DESIGN	P	DART AEROSPACE LTD		
DRAWN	RF,	HAWKESBURY, ONTA	RIO, CANADA	
CHECKED	a	DRAWING NO.	RI	EV. B
MFG. APPR.	星。	D058-676-241	SHEET	1 OF 4
APPROVED	111	TITLE		SCALE
DE APPR.	All The Control of th	CROSSTUBE ASS'Y (OH-5	8 HIGH AFT)	NTS
		CODYDICUT @ COOR DV DADT	AEDOCRACELED

DRAWING NO.	TITLE	REV. B	DART AE	ROSPACE LTD	D.E.O. NO.		SHEET NO.	SCALE
D058-676-241	CROSSTUBE ASS'Y (O	H-58 HI AFT)	ENGINEE	RING ORDER	D058-676-	241-B-1	SHEET 1 OF 1	NTS
DRAWN 97	CHECKED	A>S	MFG. APPR.	1/2	APPROVED _	1AA)	DE APPR.	
DATE 11.07	15 DATE )	1,07.20	DATE	1.07-21	DATE 1	1 - 1 1	DATE 11-07.21

REPLACE MAGNOBOND WITH PROSEAL.

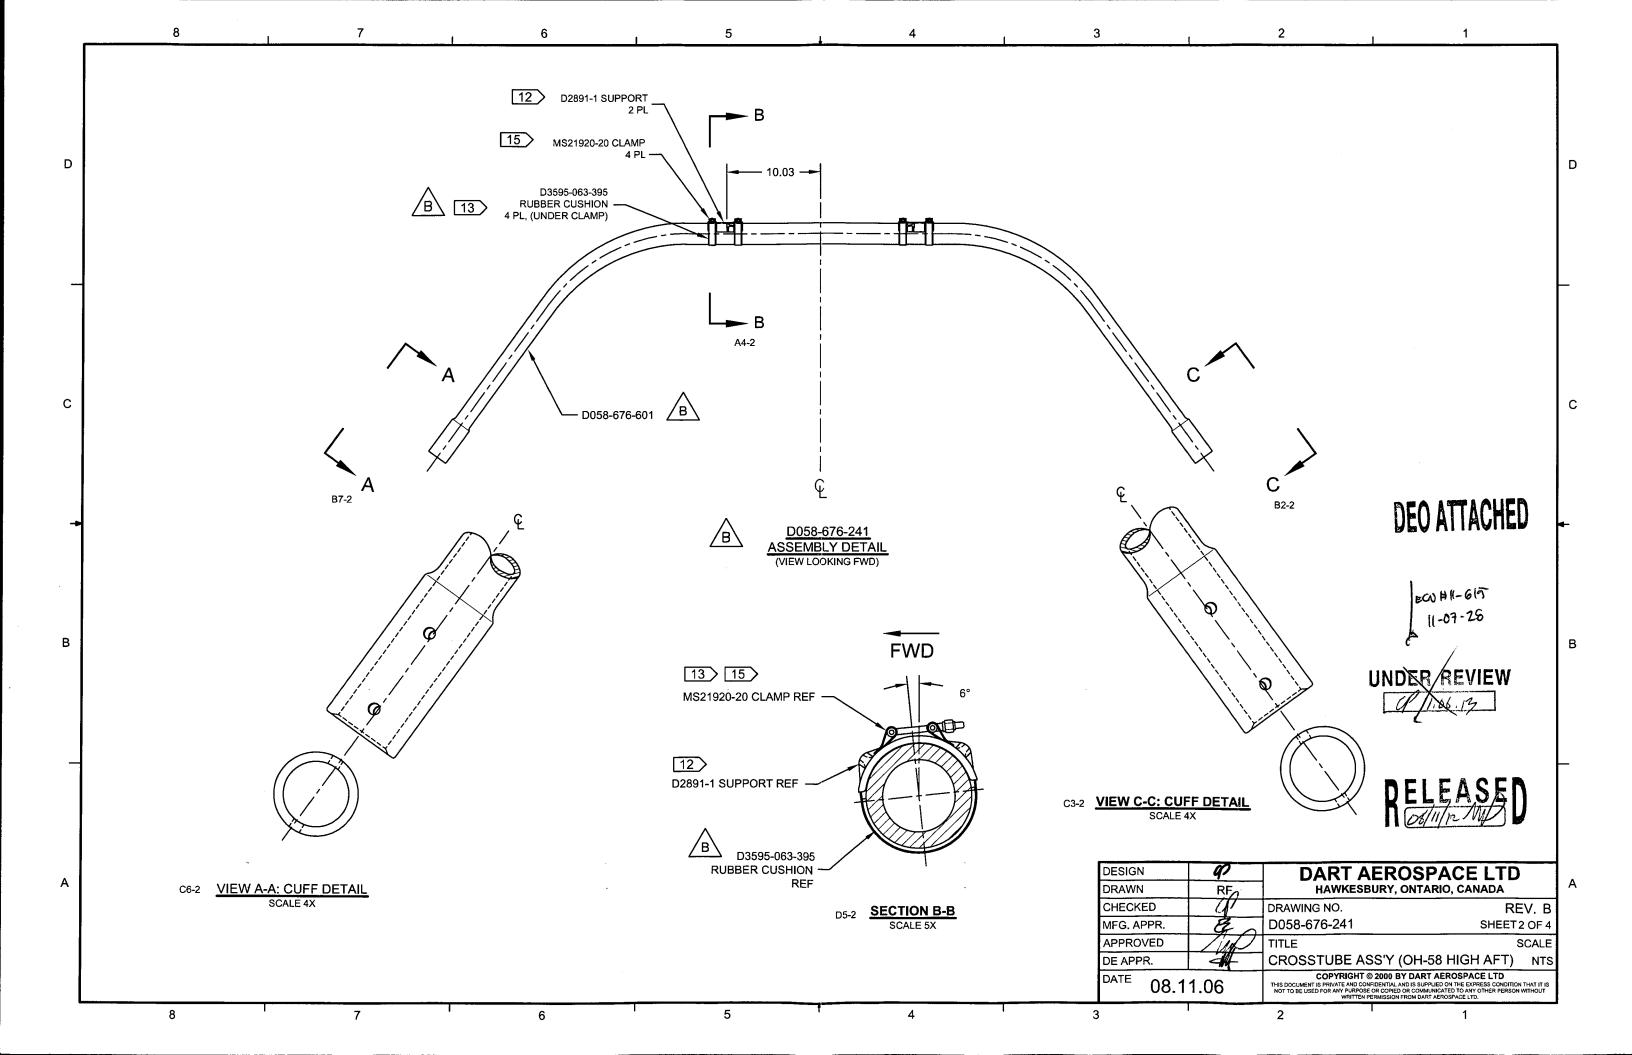
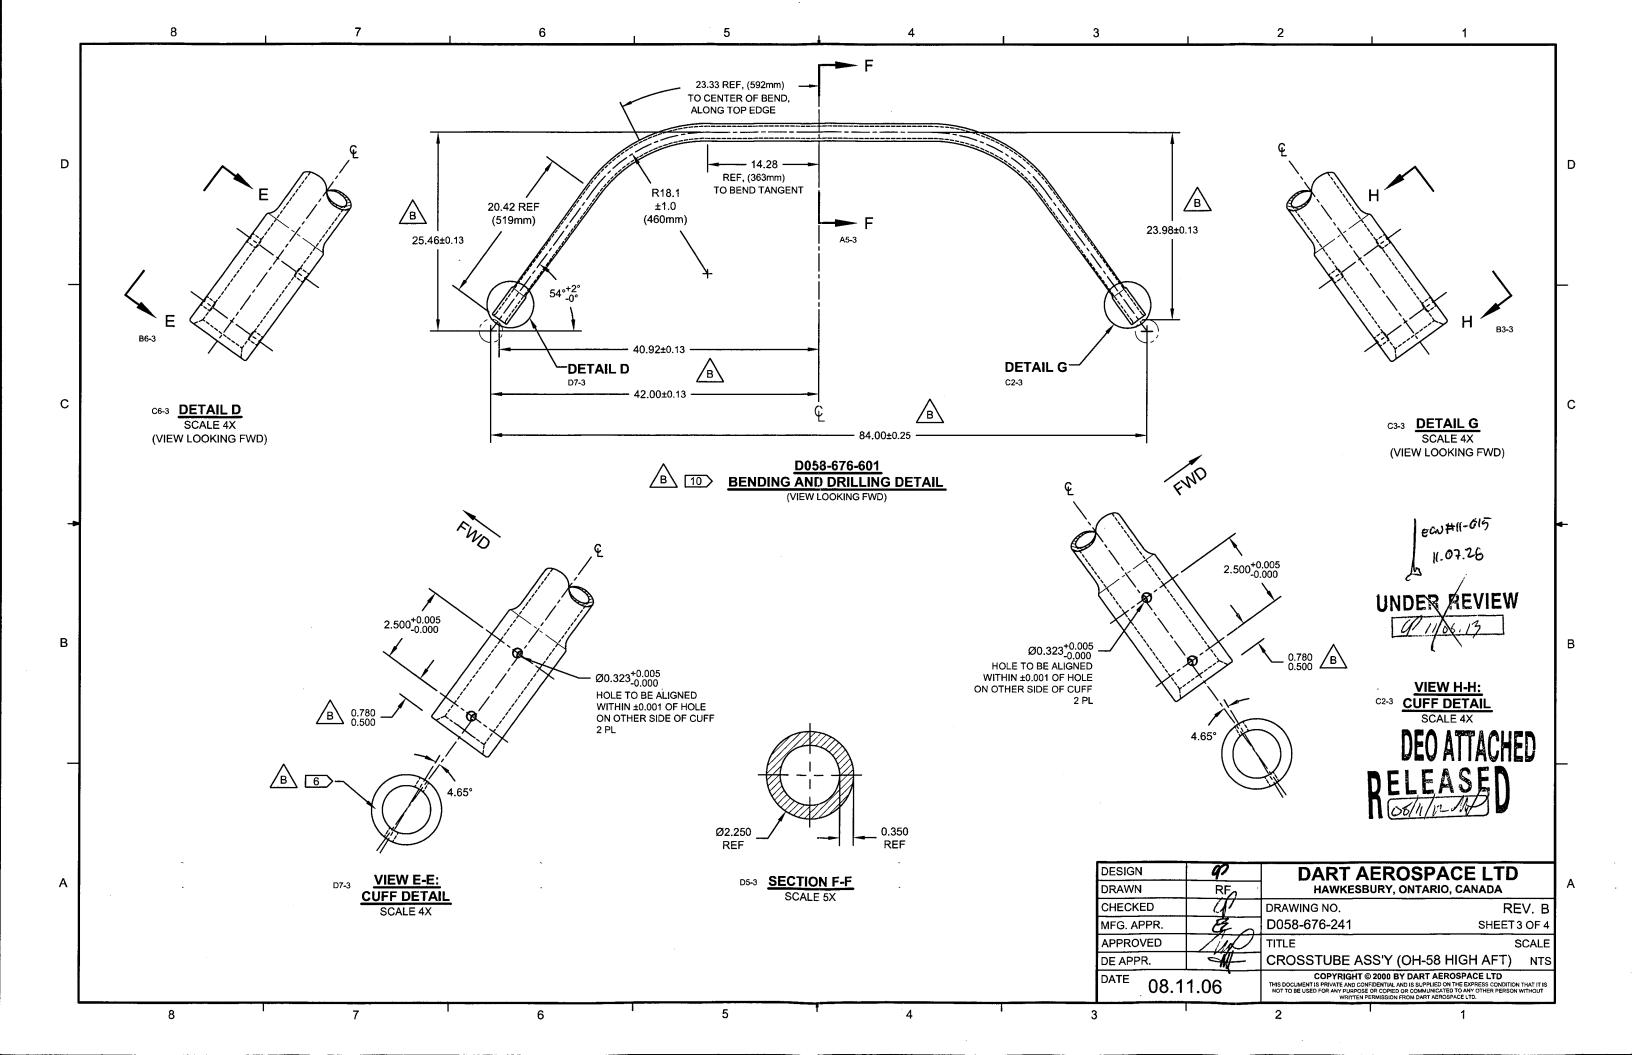
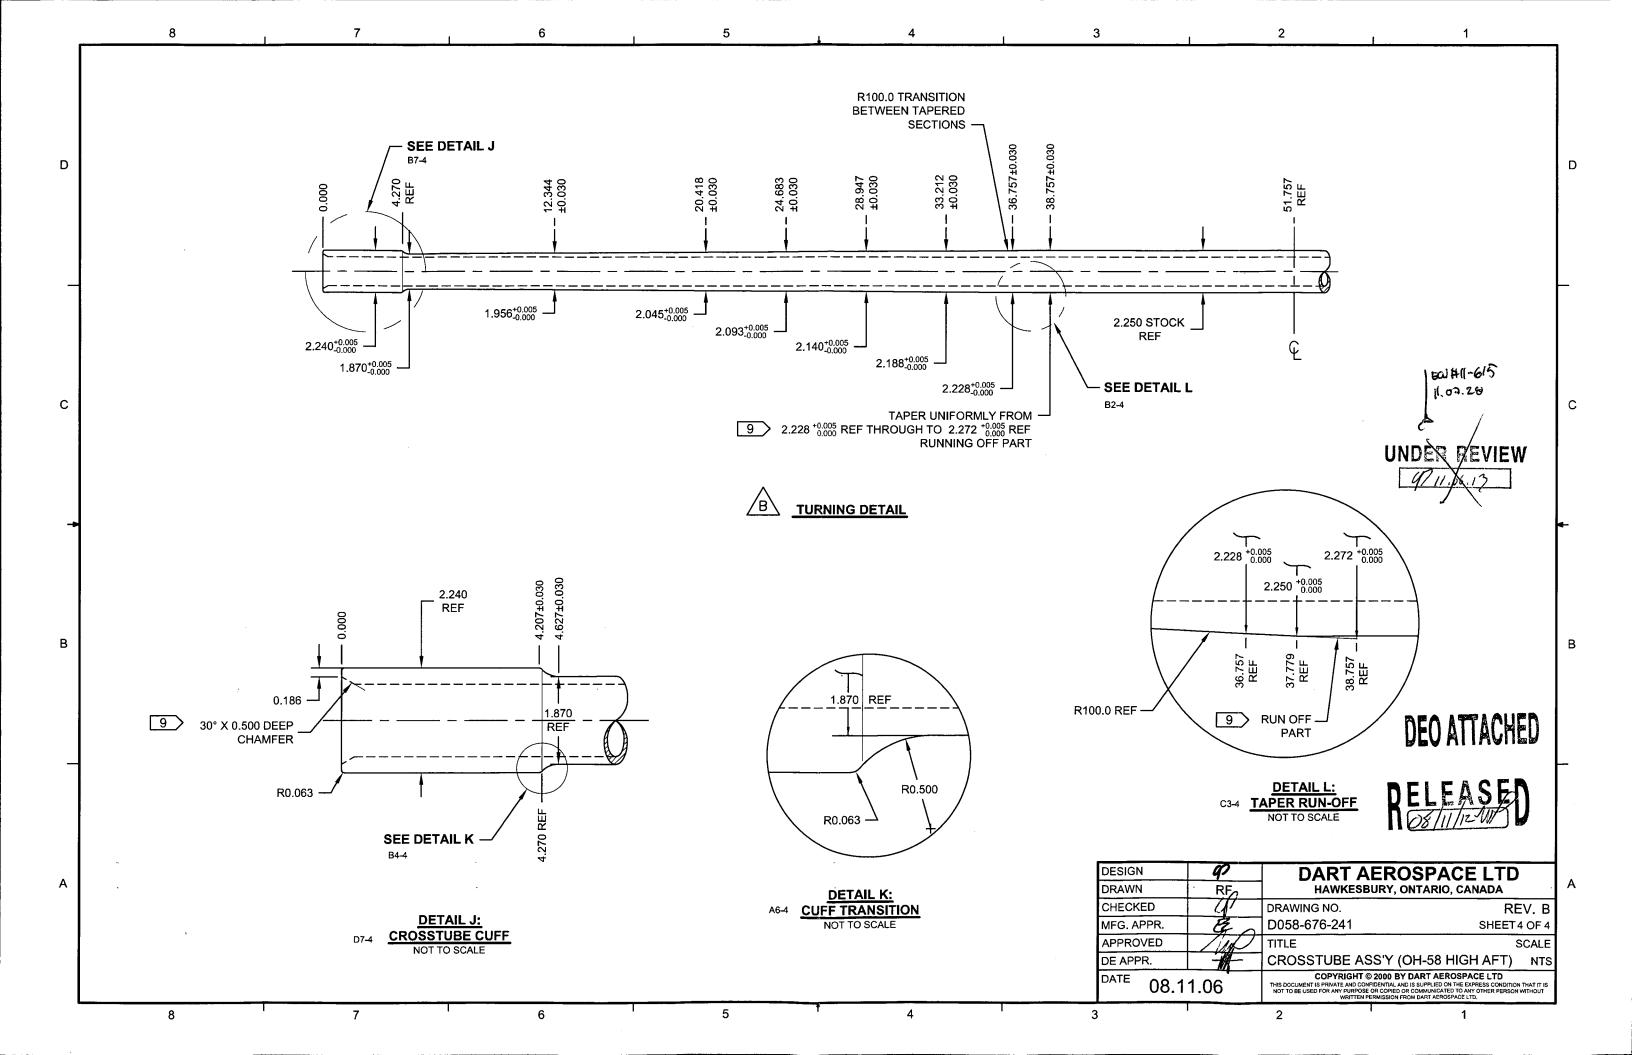
6	A/R	ROCKWELL SPECIFICATION RBO-120-023
į		ADHESIVE (TEXTRON/BELL SPEC. 299-947-100,
		 TYPE II, CLASS 2 ADHESIVE)

NOTE 12 & 15, SHEET 1 IS AMENDED AS FOLLOWS:

- 12) INSTALL D2891-1 SUPPORT USING 0.03" TO 0.06" THICK LAYER OF MAGNOBOND 6398 PER QSI 015. LET CURE FOR 12 HOURS AFTER INSTALLATION AND PRIOR TO PACKAGING.
- 15) TORQUE CLAMPS 80 TO 100 IN-LB. ENSURE AT LEAST 1.5 THREADS SHOWING IN SAFETY AND THAT NUT HAS NOT BOTTOMED-OUT AFTER TORQUING.

Item	Qty -241	Part Number	Description
6	A/R	PROSEAL 890 B-2	SEALANT, AMS-S-8802 CLASS B-2

- 12) TO INSTALL D2891-1 SUPPORT: ABRADE MATING SURFACE OF SUPPORT AND CROSSTUBE WITH 180-GRIT SANDPAPER AND REMOVE RESIDUE WITH MEK (OR EQUIVALENT). APPLY A 0.04" TO 0.07" THICK LAYER OF PROSEAL 890 CLASS B-2 (OR AMS-S-8802 CLASS B-2) SEALANT TO MATING SURFACE OF SUPPORT.
- 15) TORQUE CLAMPS 80 TO 100 IN-LB. ENSURE AT LEAST 1.5 THREADS SHOWING IN SAFETY AND THAT NUT HAS NOT BOTTOMED-OUT AFTER TORQUING. PRIOR TO PACKAGING, RE-CHECK TORQUE ON CLAMPS AFTER PROSEAL 890 SEALANT HAS CURED FOR 72 HOURS.
